# Texas Commission on Environmental Quality

Facility Name: City of Waco Transfer Station Facility

August 15, 2023  
SCS Project No. 16222063.00

Subject: Subchapter T Development Permit Application for Enclosed Structure  
New Building for MSW Transfer Station at City of Waco Landfill, MSW Permit No. 1039  
Proposed Development Permit Application No. - TBA  
Response to Notice-of-Deficiency (NOD) Email, Dated July 25, 2023  
McLennan County, Texas.  
Tracking No. 28604235; RN TBA/CN600131940

PIPING PLAN  
NTS

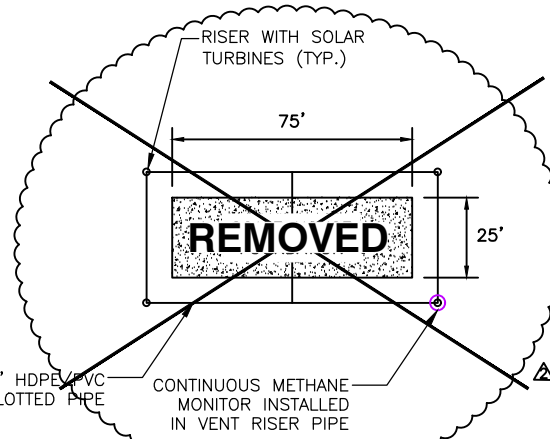
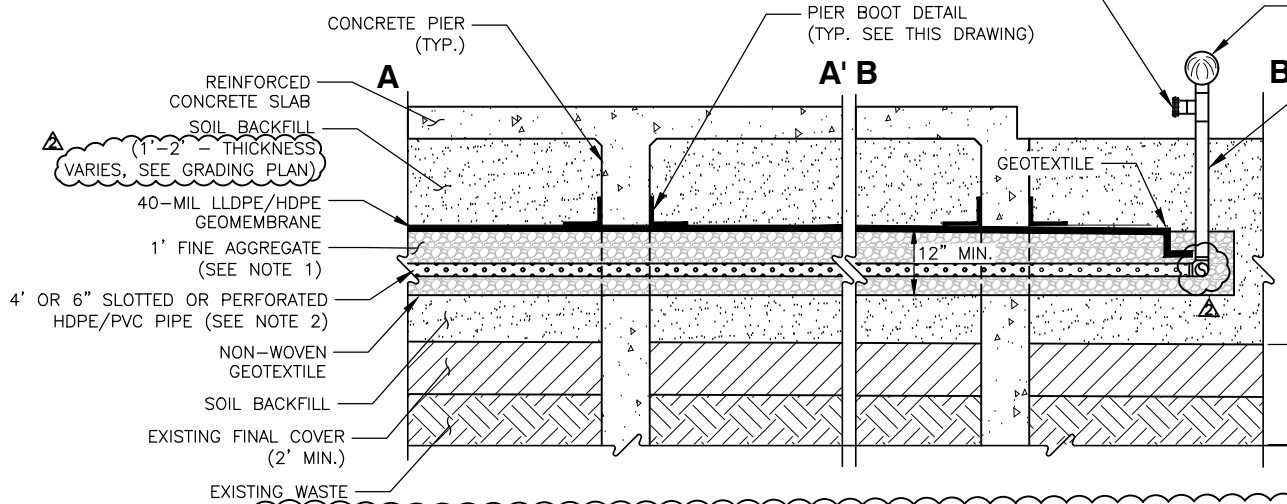
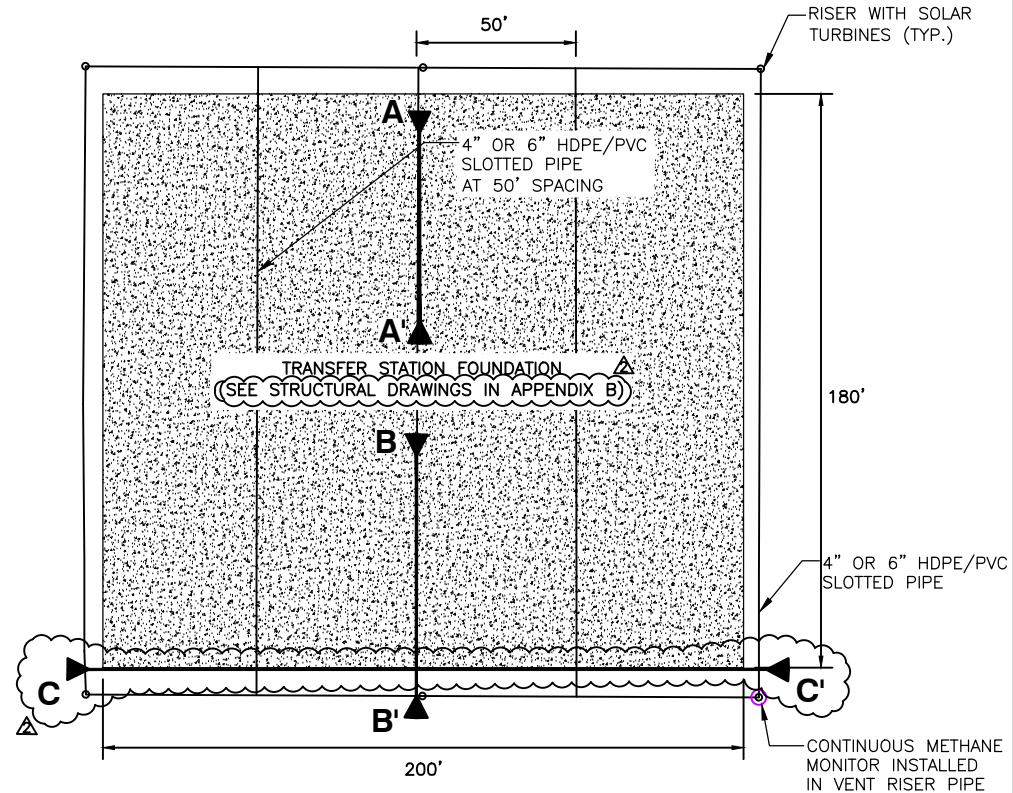
5. Section 13, Foundation Plans, Note 1, indicates permeable layer specification as coarse sand or fine gravel. Revise the material to be open-graded consistent with 30 TAC 330.957(m)(1)(A).

9. Provide a cross-section along the edge of the foundation. Cross section B-B' does not seem to be representative of the intended drawing section. Indicate the thickness of the fill material above the 40-mil LLDPE/HDPE Geomembrane.

10. Section 13, Drawing 13.1, provide backfill material specifications. No excavated waste intermixed with soil shall be used as soil backfill.

***The note 1 on drawing 13.1 has been revised to include the requested change.***

***A new cross section has been added to Drawing 13.1 along the edge of the foundation, as requested. The existing cross sections A-A' and B-B' on Drawing 13.1 are representative of the transfer station building foundation, but has been revised to clarify the thickness of soil fill above the 40-mil LLDPE/HDPE geomembrane per your request.***

***Section 3.6 and Drawing 13.1 have been revised to include backfill material specifications, as requested.***

- FINE AGGREGATE SHALL BE COARSE SAND OR FINE GRAVEL THAT IS AN OPEN GRADED CLEAN MATERIAL.
- SLOTTED OR PERFORATED PIPING SHALL EXTEND AROUND THE BUILDING PERIMETER AND BENEATH SLAB AS SHOWN ON PIPING PLAN DETAIL.
- PROVIDE FITTED HDPE BOOTS FOR A1C FOUNDATION PIERS (SEE PIER BOOT DETAIL, THIS SHEET)
- CONTINUOUS METHANE MONITORS SHALL BE INSTALLED IN THE VENT PIPE RISER. REFERENCE PIPING PLAN (THIS PAGE) FOR VENT RISERS AND METHANE MONITOR LOCATIONS.
- PROVIDE 4" OR 6" CAPPED PORT FOR FUTURE BLOWER IF NEEDED.
- PIERS SHALL EXTEND INTO UNDERLYING BEDROCK AS INDICATED ON STRUCTURAL PLANS S1-S5 IN APPENDIX B.
- EXCAVATED WASTE THAT IS MIXED WITH SOIL SHALL NOT BE USED AS SOIL BACKFILL.

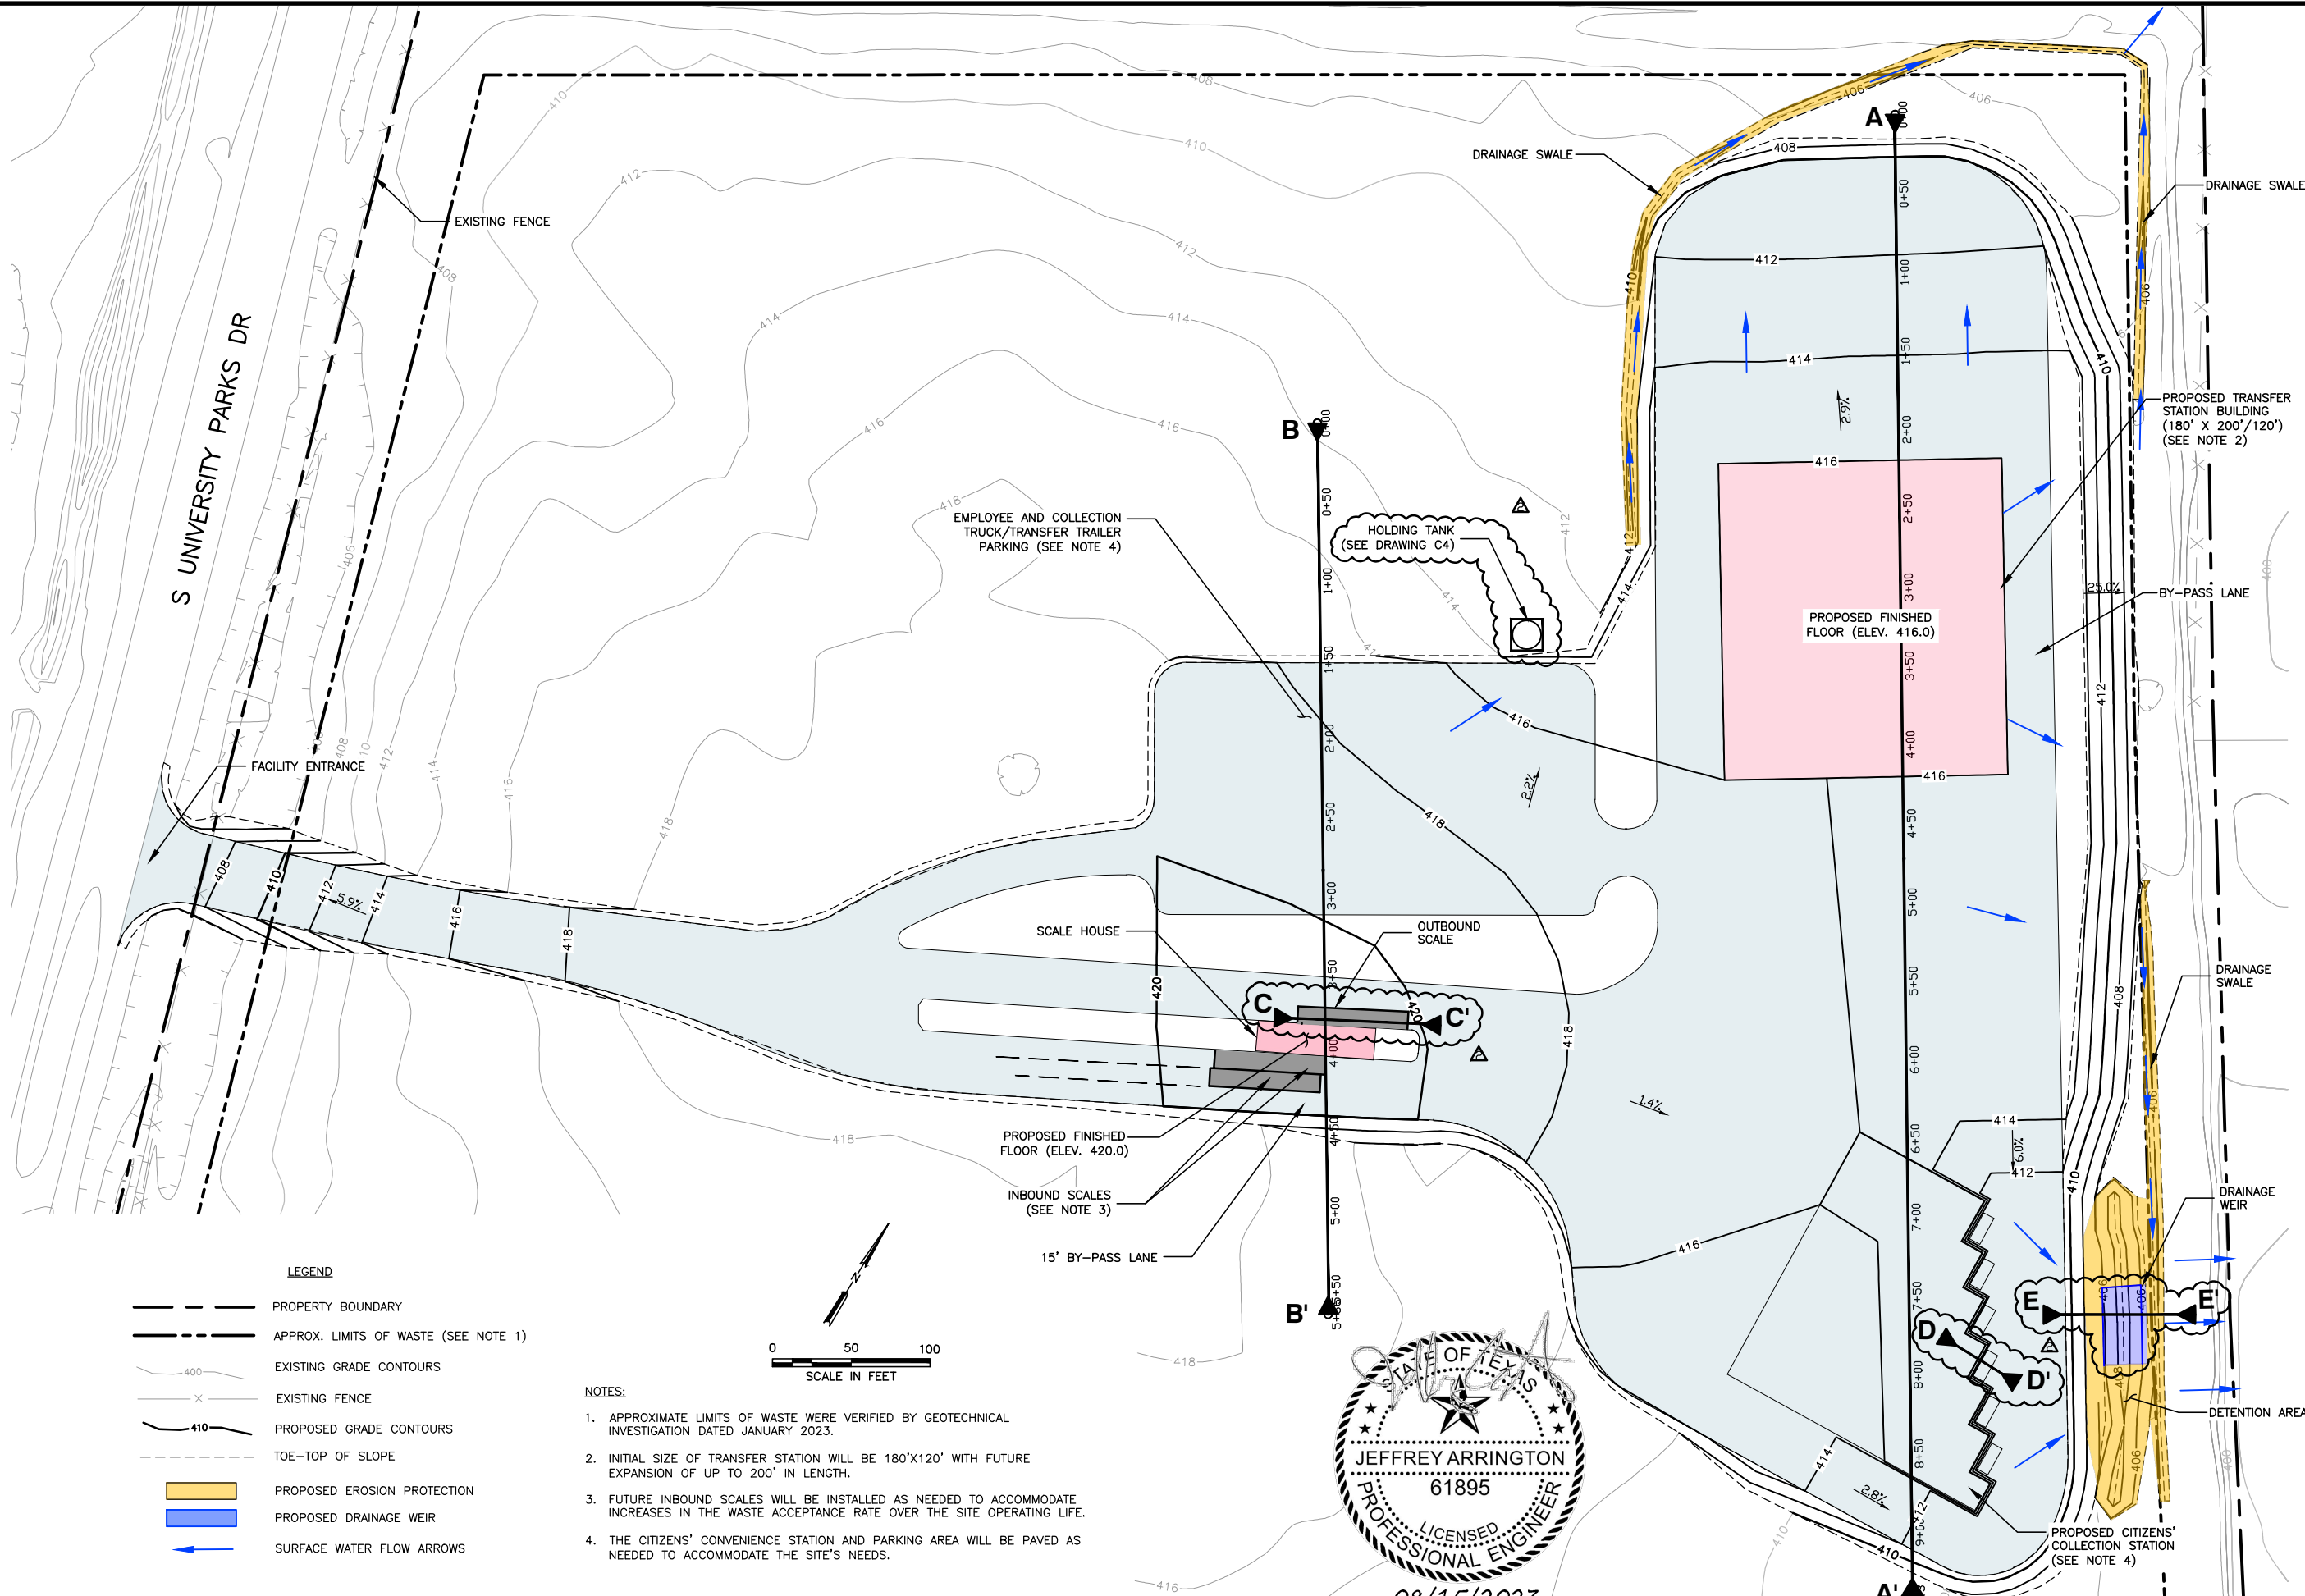
13. Provide site plan drawings that depict utility trenches. Identify the areas for utility trench section (waste encountered), and utility trench sections (no waste encountered) with reference to drawings C2 and C5.

***The location of proposed utilities lines are depicted on plan view Drawing C1. Additional information has been added to the drawing that indicates where waste is expected to be encountered. However, there is no feasible way to be sure exactly where that will occur, therefore notes were added to drawing reference the appropriate trench liner details.***
